Tree Survey Arborist Report and Construction Review

82 Linda Vista Ave
Atherton, CA 94027

Comment Response

RE: 82 Linda Vista Ave, Atherton, CA 94027

2 Diagrammatic Structural Plan
SCALE: 1/4" = 1'-0"

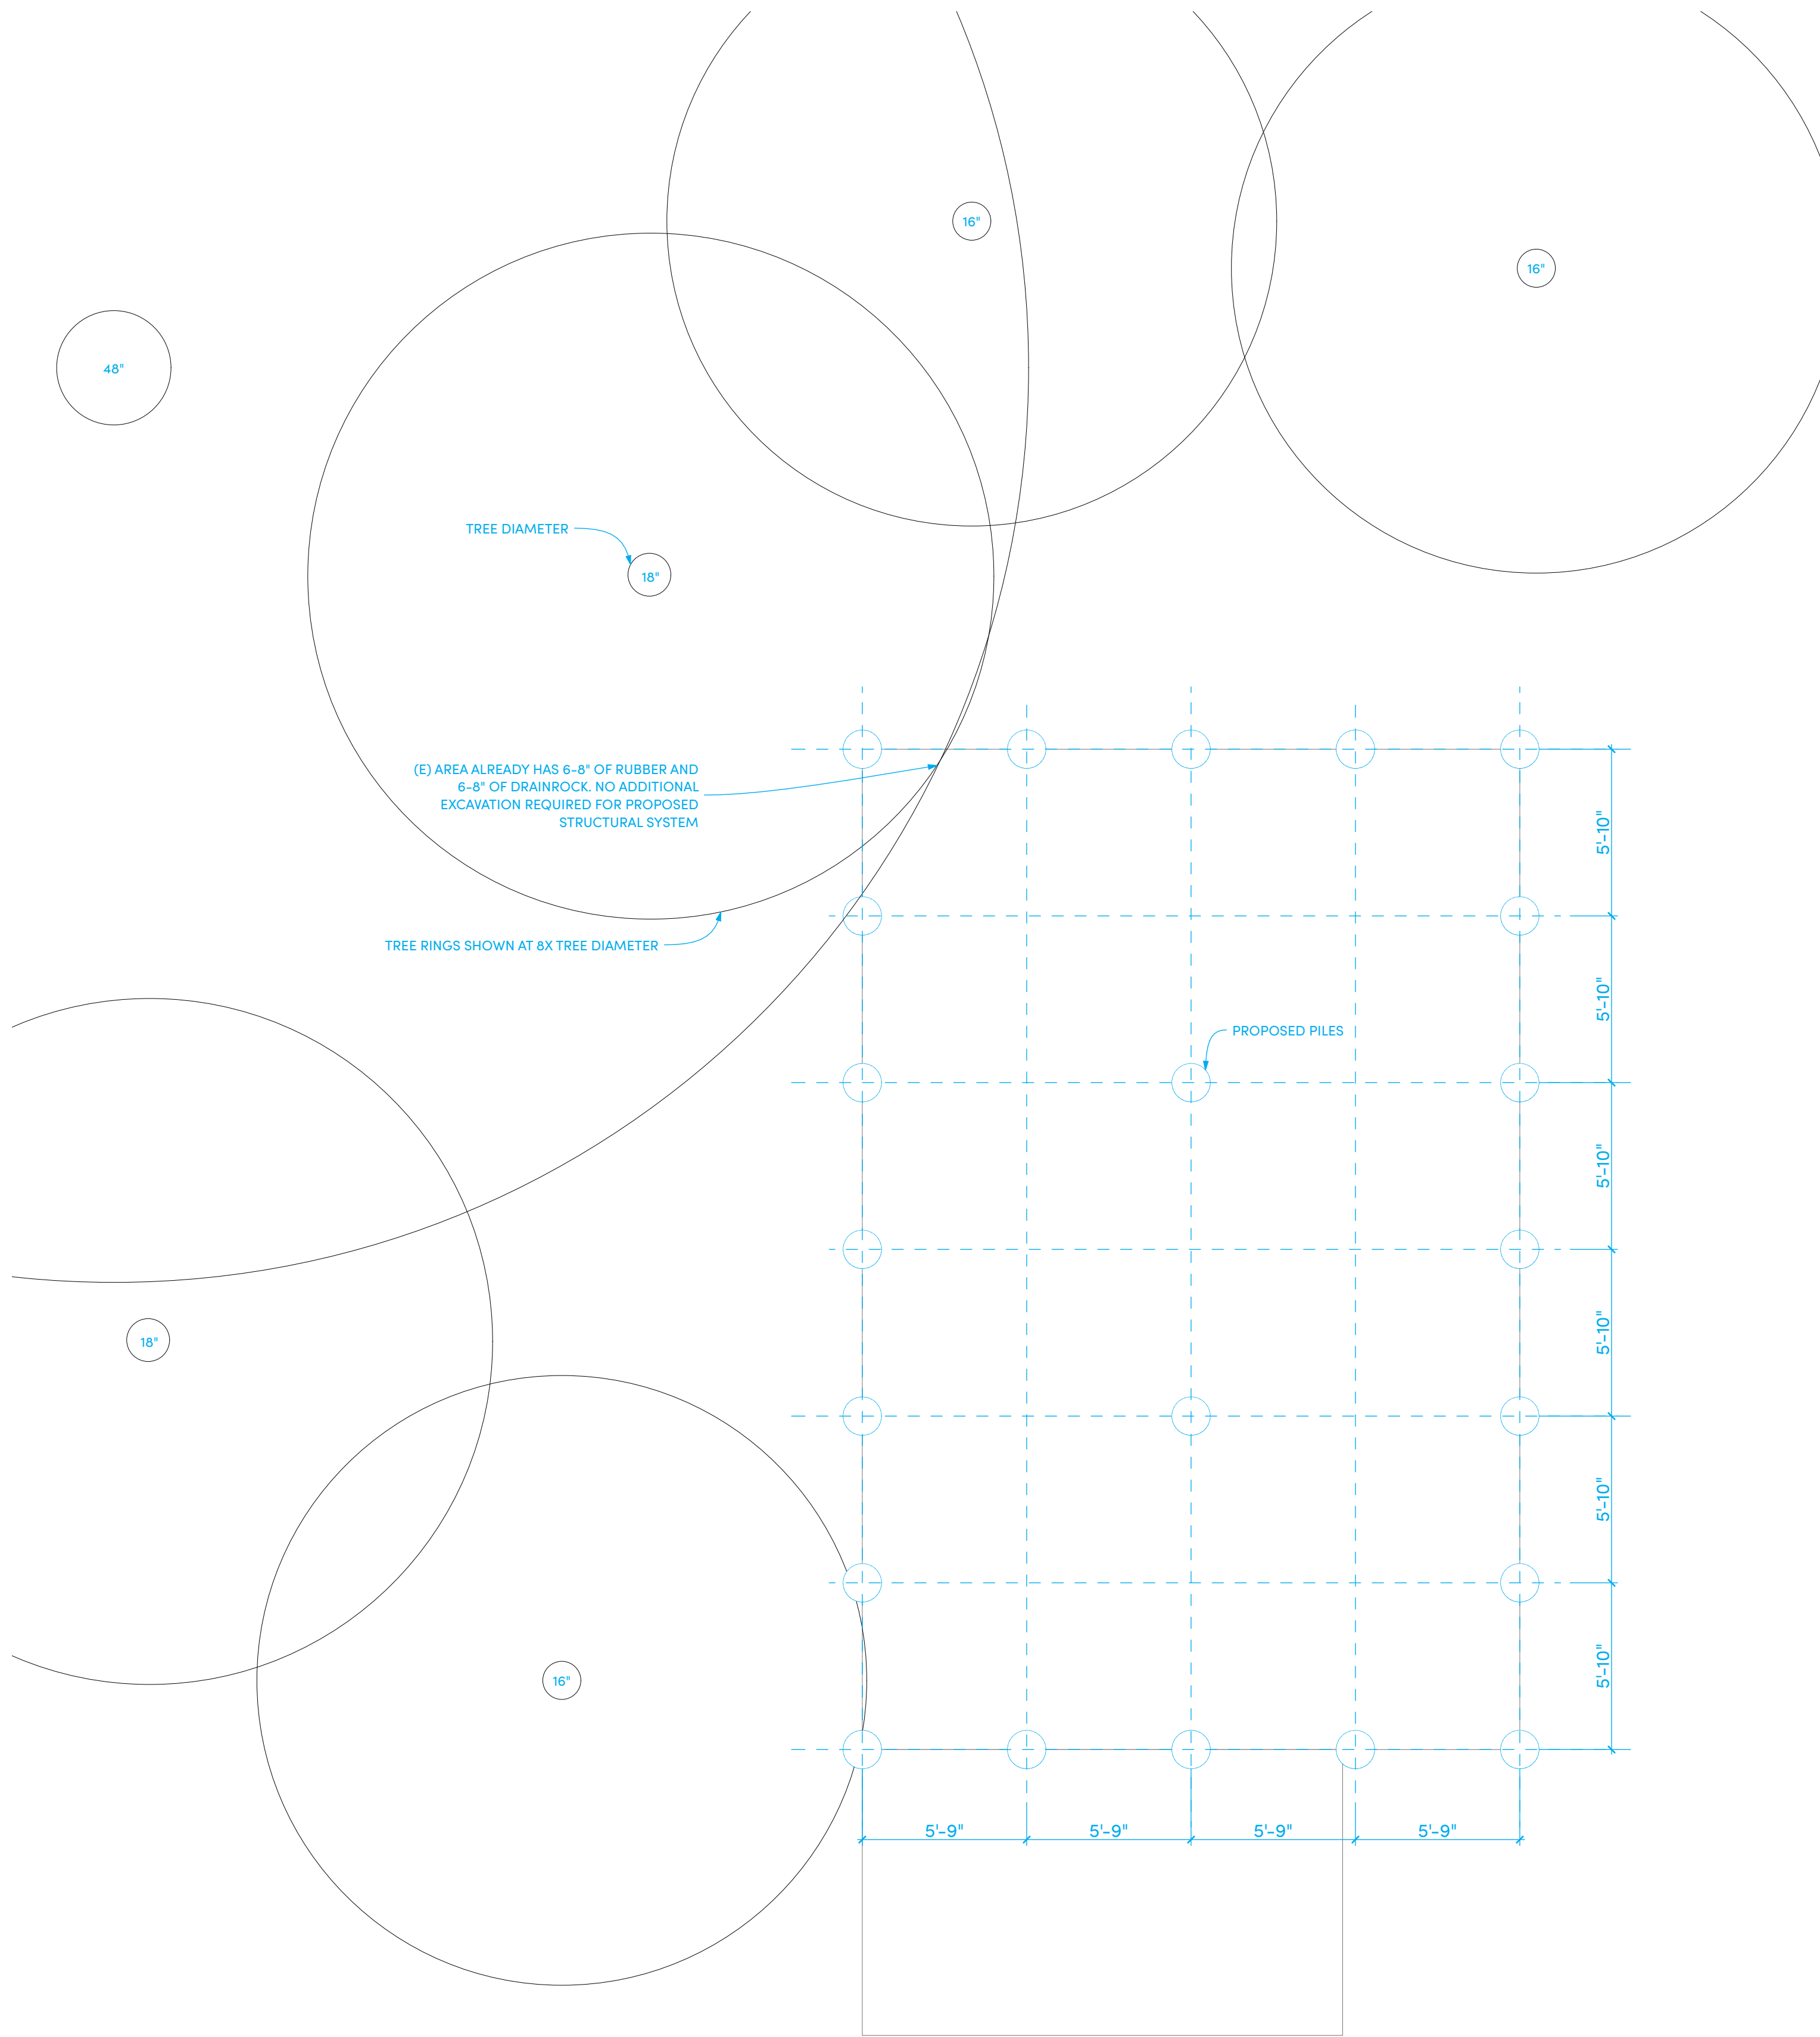
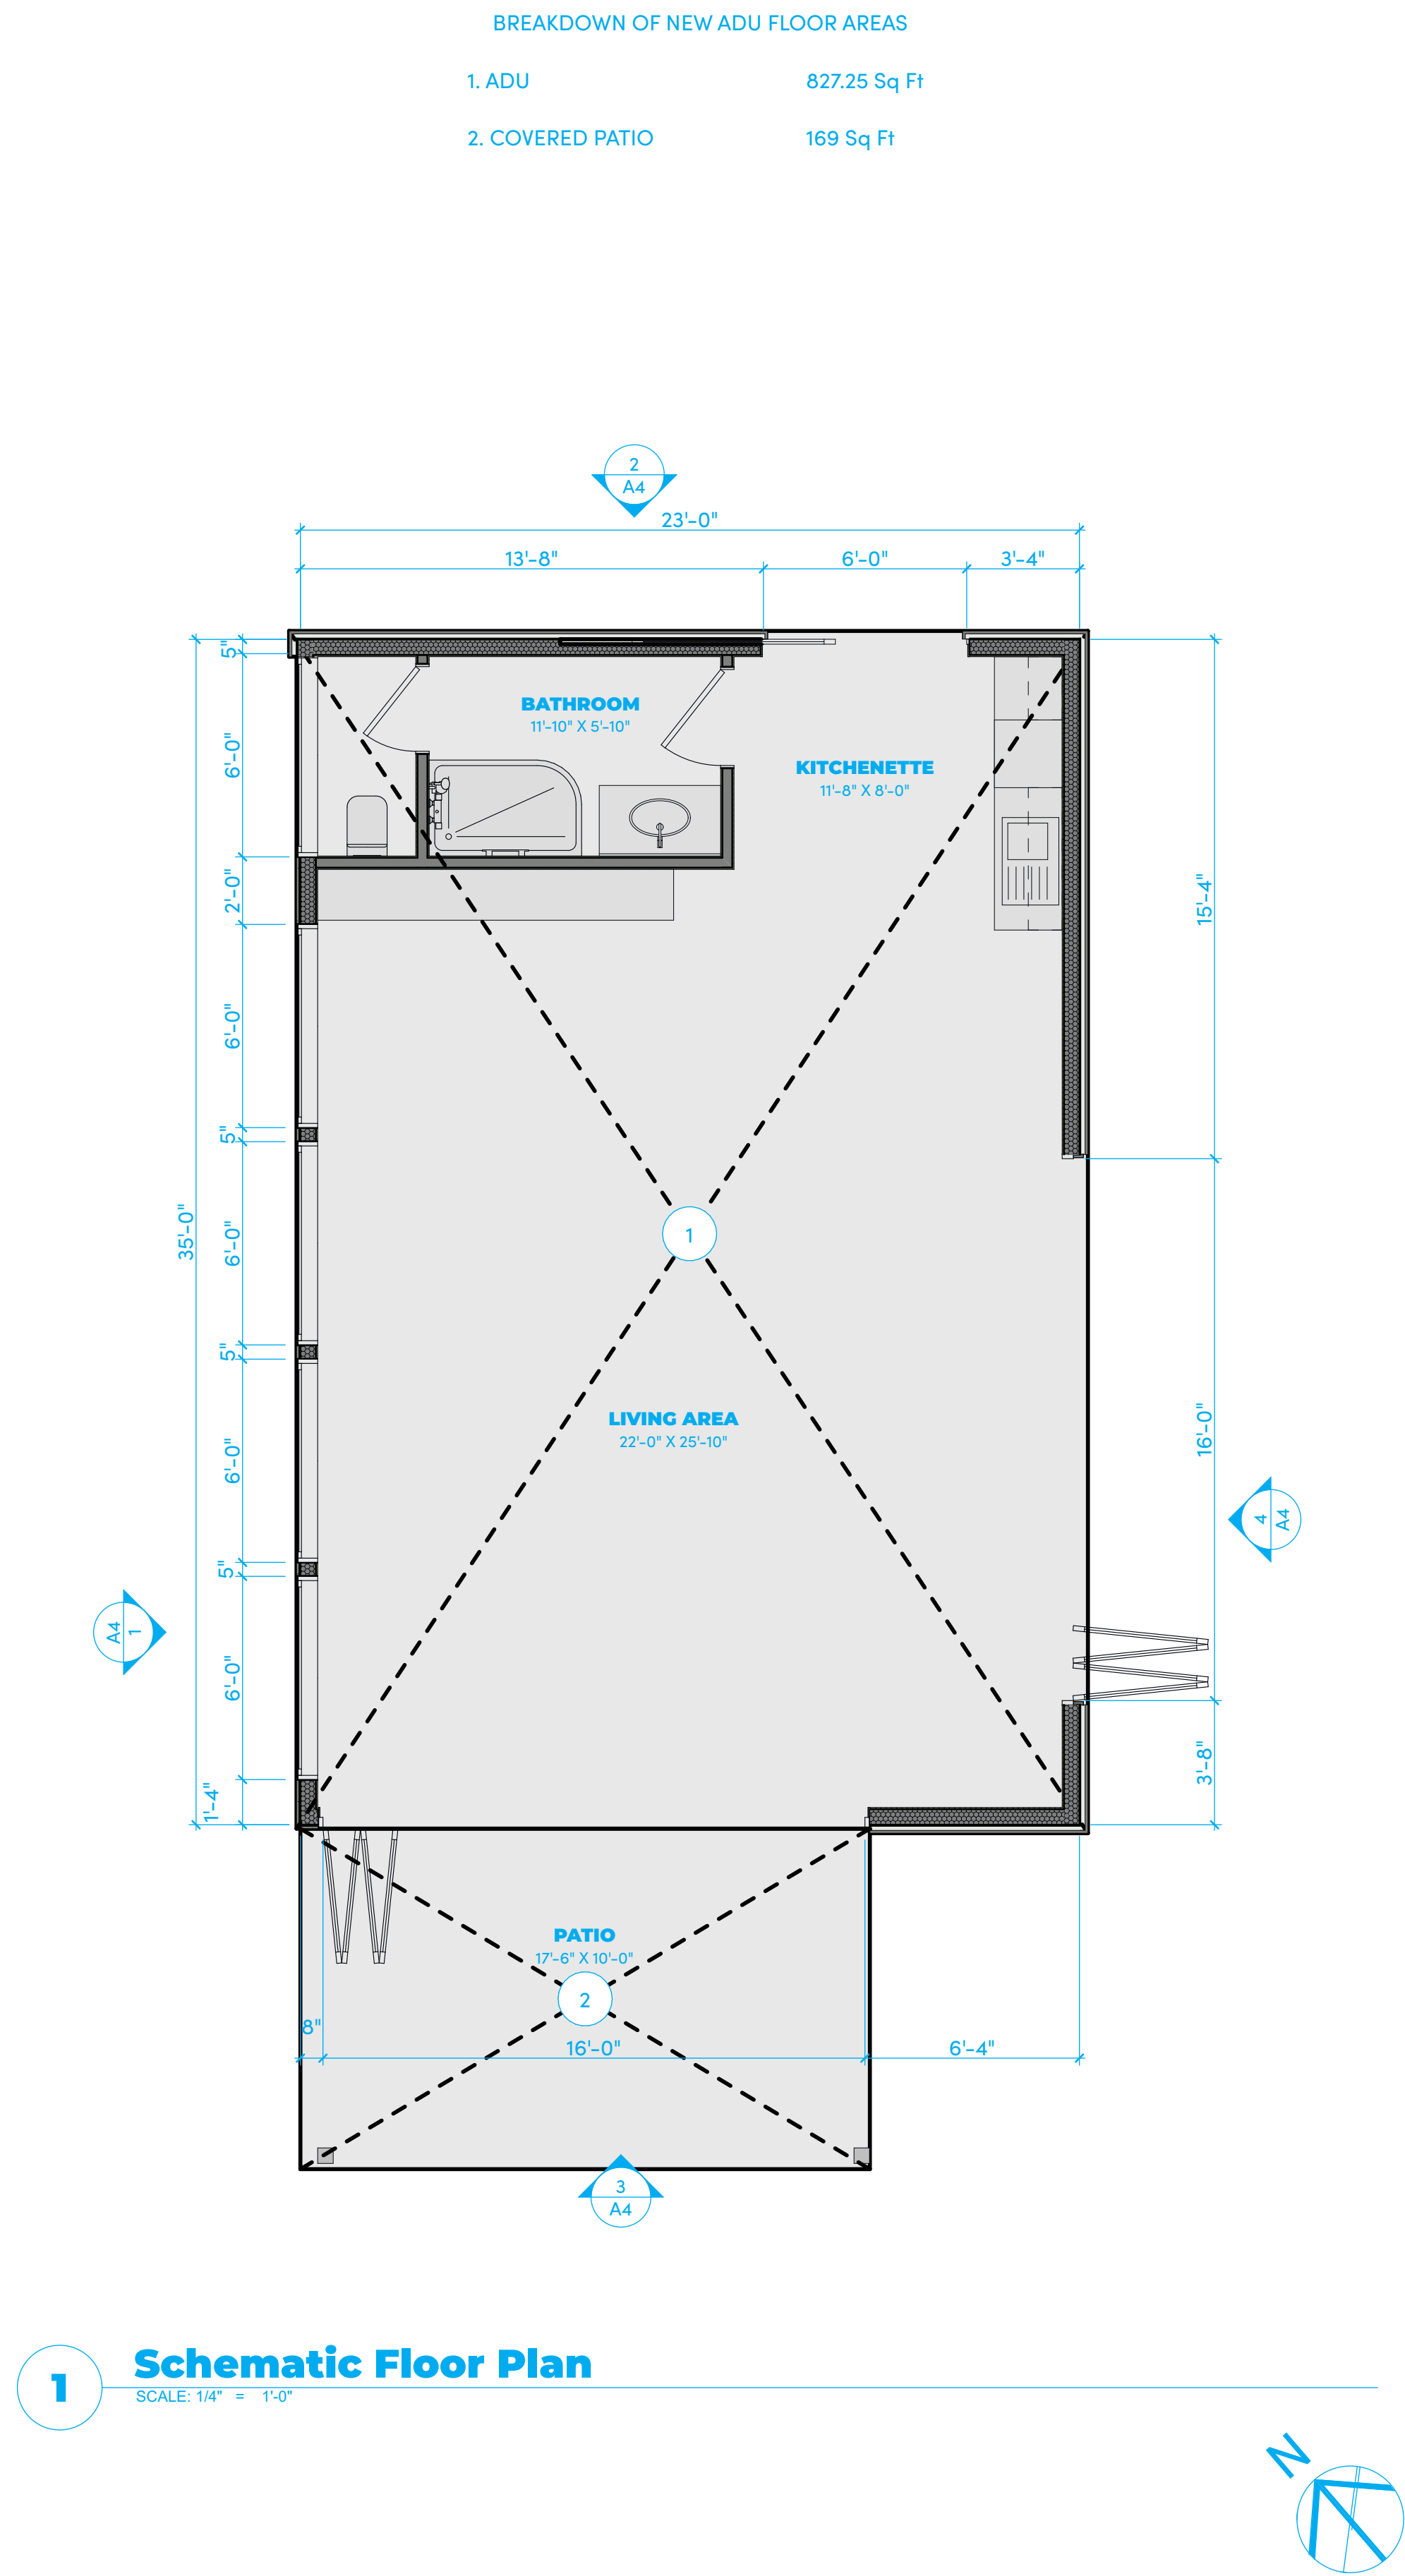
1. State what TPZ exception they are asking for the 48" Redwood and the 18" Redwood. They just say it's a bit under 8x, but I need specifics.
2. I need a report that opines on these two specific trees and what effects on the trees will be and mitigation measures, etc.
3. Specifically, tree #2 on the narrative is 48" diameter, but the diameter on the inventory is 60" diameter. I need to know why there is a discrepancy. I typically only go with what is on the inventory.

1. We are requesting Tree #2, the 48" Coast Redwood (*Sequoia sempervirens*), to have a tree protection zone (TPZ) exception reduced to 7.48x trunk diameter at breast height (DBH).

- a. We are requesting Tree #4, the 18" Coast Redwood (*Sequoia sempervirens*) to have a tree protection zone (TPZ) exception reduced to 6.22x DBH.
2. Per the Project Architect, Tommy Frost, there will be only one new structural pile installed within the 8x DBH TPZ of Tree #2 and Tree #4. As stated in the arborist report, there will be no additional excavation required to install the slab on piles and grade beams ADU foundation. The ADU foundation will be laid on the same footprint as an existing playground on the property. These trees were both considered preservable due to their existing condition at the time of the tree survey. With the use of the pre-existing playground foundation footprint and pier on slabs and grade beams foundation for the ADU, we do not expect there to be significant impacts to the two trees in question. Should any 2" or greater diameter roots be discovered during the structural pile installation, the Project Arborist shall make a site visit to assess potential ramifications to the trees and provide additional recommendations to preserve the health of the trees. To mitigate construction stresses to Tree #2 and Tree #4, we recommend cyclone fencing be installed at the TPZ exception encroachment distances. We recommend hand spreading 6"-8" of mulch within each tree protection zone to enhance nutrient cycling and moisture retention in the soil. Additionally, we recommend irrigating the trees of concern to a depth of 12" every 4 weeks until winter rains are able to accomplish the

same goal. With the protection measures and construction practices in place, we do not anticipate Tree #2 and Tree #4 being negatively affected by the proposed ADU.

3. Tree #2 is located on a neighboring property and was assessed visually by the Project Arborist at the time of the tree survey. The Project Architect has since had a follow-up meeting with the town planner onsite and determined that the tree is 48" diameter, consistent with the original topographic survey.
